PROJECT NAME: Air Cargo Access Improvements at
Palm Beach International Airport

PROJECT NUMBER: Department of Airports Project No. PB 25-9

ADDENDUM NUMBER 2

Date of Issue: March 6, 2026

G-02.06

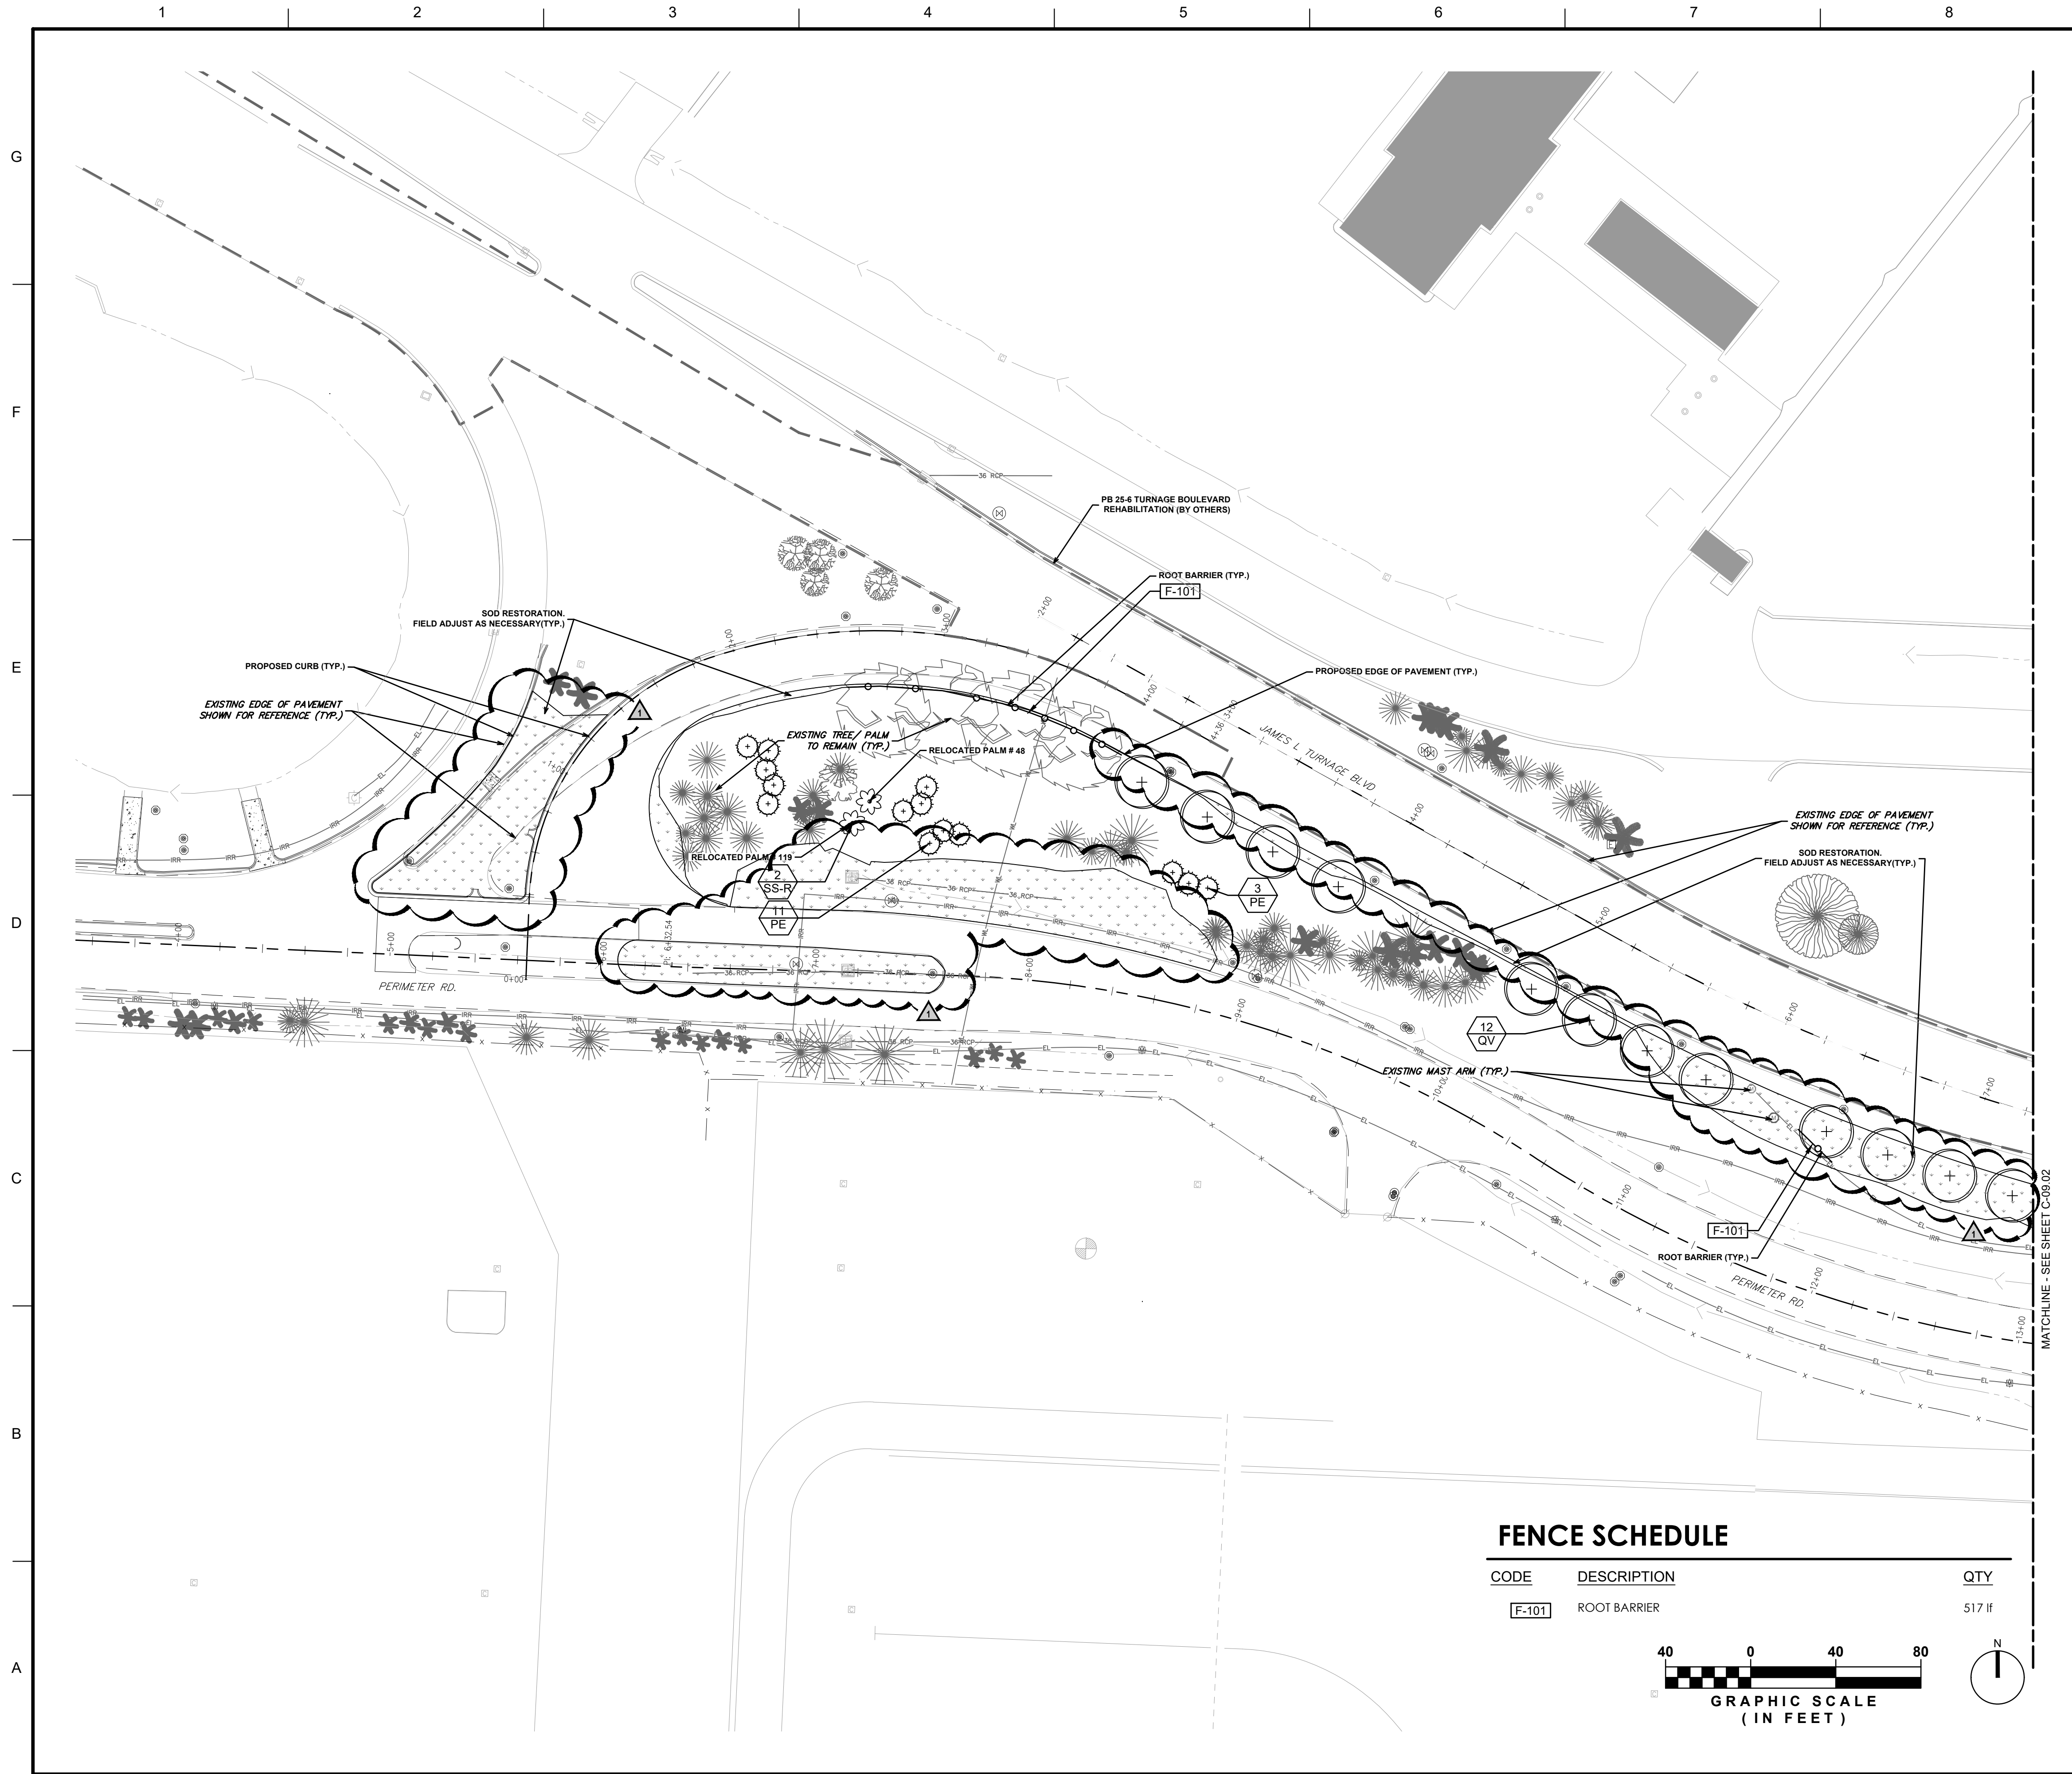
2.2. G-02.06 TEMPORARY TRAFFIC CONTROL PLAN - PHASE 2*

Insert Sheet into Plan Set. Sheet listed in Index but missing from PB 25-9 - Air Cargo Access Improvements - Plans.

SHEET ID
C-10.01

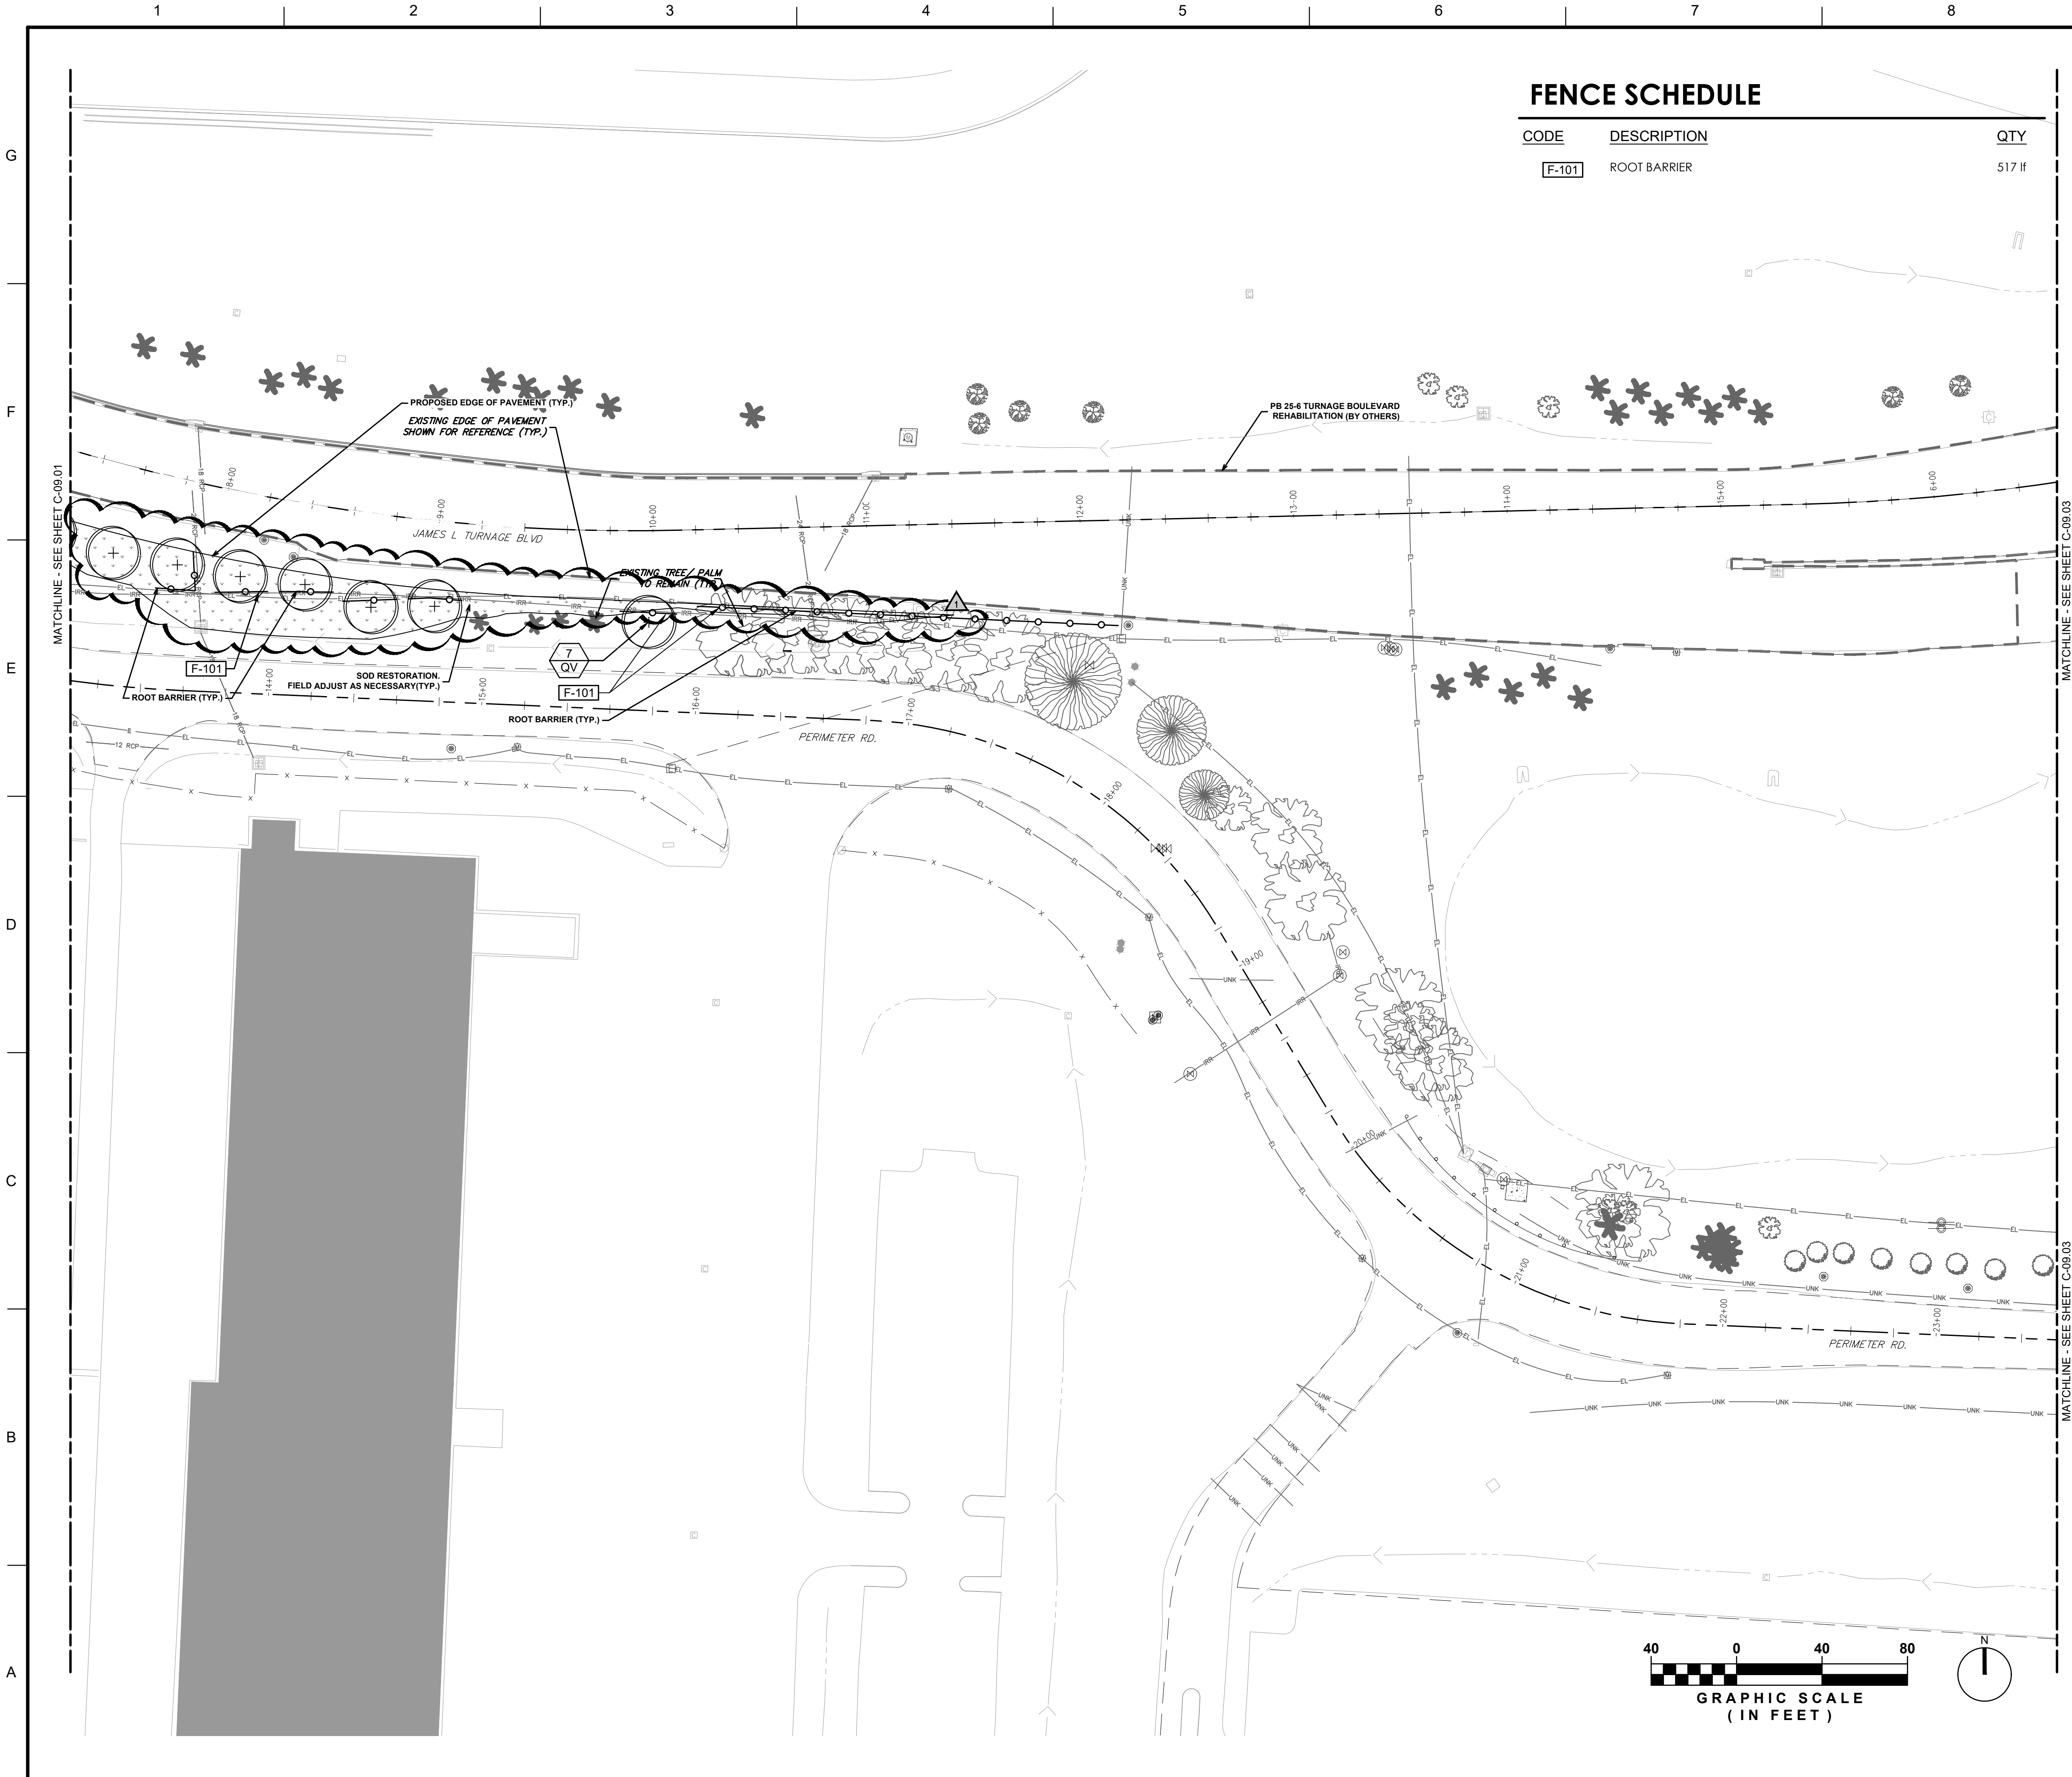
2.3. C-10.01 LANDSCAPE PLAN*

Sodding limits shown on plan sheet have been updated to match limits shown on Sheet C-02.01.

4.16. Can the floritam sod quantity be verified? I am coming up with approximately 2/3 of the actual total from the landscape plans.

- 4.27. Plan Sheets G-01.01 and C-10.01 show differing sod limits; please confirm which plan sheet governs. Can the areas designated for St. Augustine Grass versus Performance Turf be called out on the plans as well?**

Response: Sod limits have been updated on Sheet C-10.01 and C-10.02, see Section 2 above for additional information.

Response: Sod limits have been updated on Sheet C-10.01 and C-10.02, see Section 2 above for additional information.
